service bulletin

92-2

Oil Tank Leak - 50/60

Mariner and Mercury 50 and 60

a - Filler Neck Seam of Oil Tank

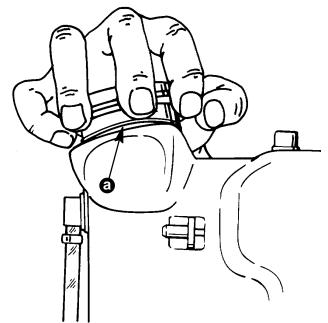
Outboards listed, may have an oil leak at the seam between the filler neck and the tank body. Affected oil tanks may leak oil while outboard is laid down in shipping carton or when outboard is tilted up on boat transom.

The oil tank of outboards listed, should be inspected during pre-delivery or when unit is in for service work. Visually inspect seam of filler neck for openings, while trying to tip filler neck from side to side and back and forth.
